APPLICATION FOR PERMISSION UNDER SECTION 16 OF THE TOWN PLANNING ORDINANCE (CAP.131)

(a) Proposed use(s)/development 擬議用途/發展	Proposed Temporary Warehouse for Storage of Construction Materials (Timber and Metal) (Please illustrate the details of the proposal on a layout plan) (請用平面圖說明擬議詳情)

Date: 17 February 2023
Your Ref.: TPB/A/YL-KTS/946
Our Ref.: LDS/PLAN/6859

Table 1: Responses to Comments from Government Department on Planning Application No. A/YL-KTS/946 (17 February, 2023)

Drawing No. 001A

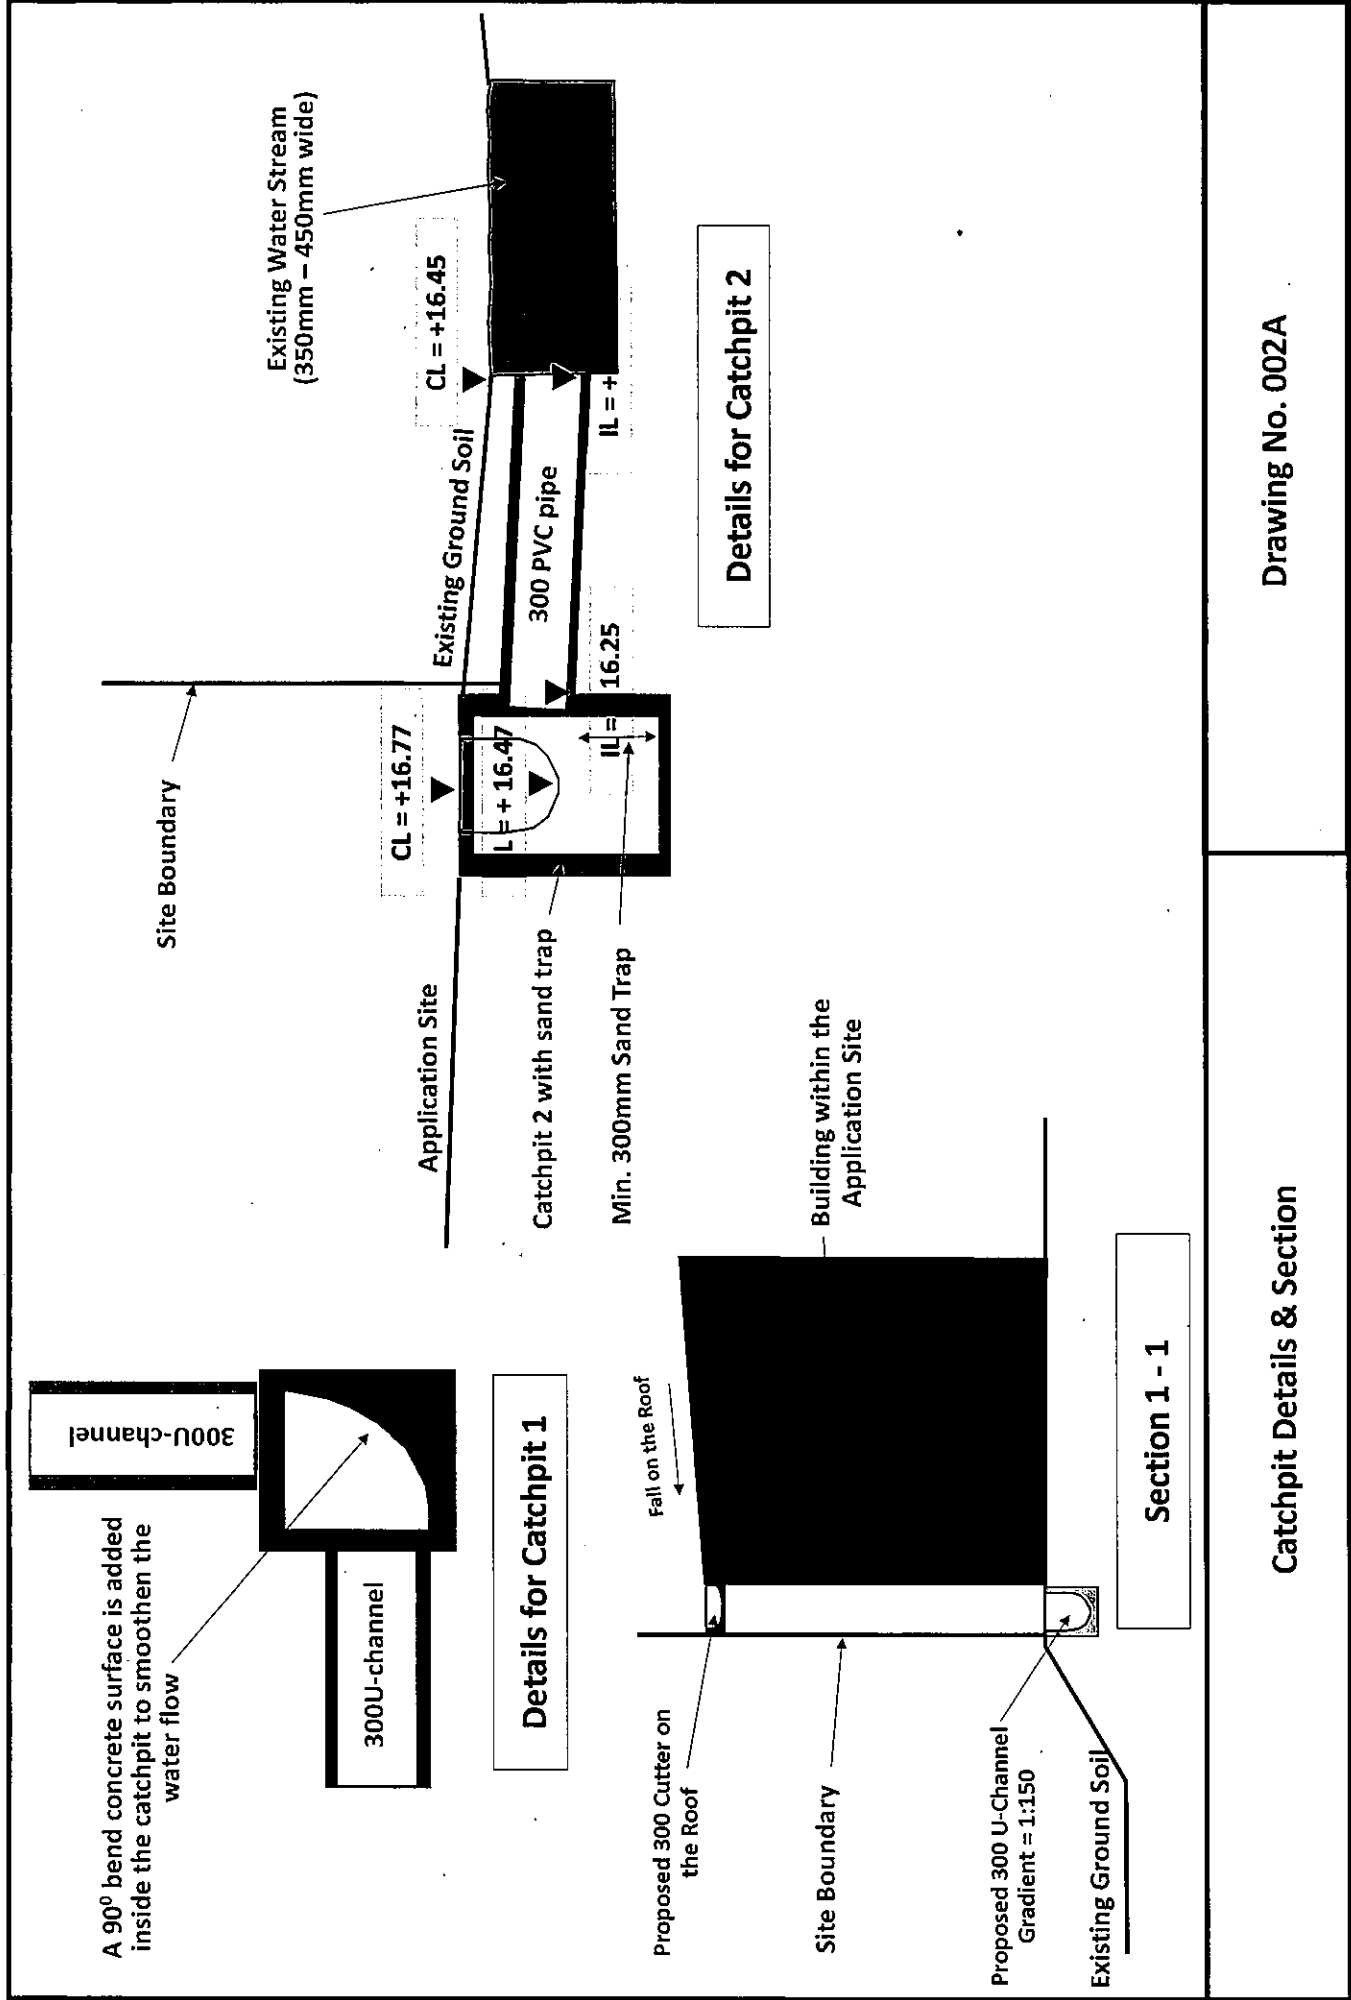
2. Drainage Services Department		
Please find below comments on the revised drainage proposal:		
(a)	Peripheral surface channels shall be provided along the site boundary to collect the surface runoff accrued on the application site.	(a) Peripheral surface channels will be provided along the site boundary to collect the surface runoff accrued on the application site. Please refer to the revised Drainage Plan attached (see Annex 2).
